Operator: HIGHPOINT OPERATING CORPORATION

Location Name: Dutch Lake Pad 16-24H

Loc ID: 422838

Inspection: 696305334

Exhibit A

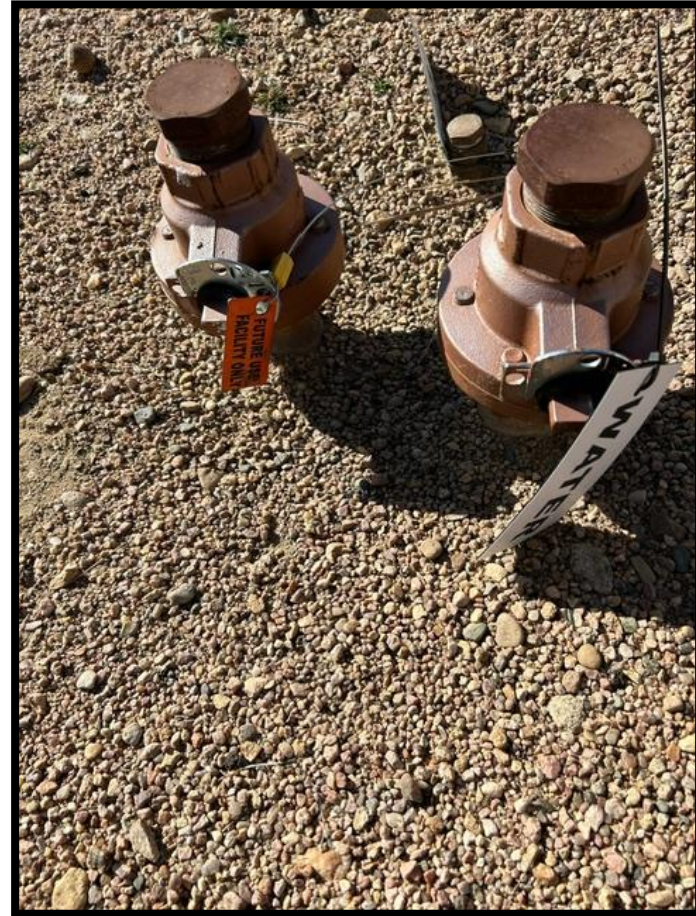
CA: Overgrown Vegetation on Location; see photos. Comply with Rule 606.

CA Resolution: Operator has addressed and cleared overgrown vegetation and weed debris from location to comply with Rule 606.
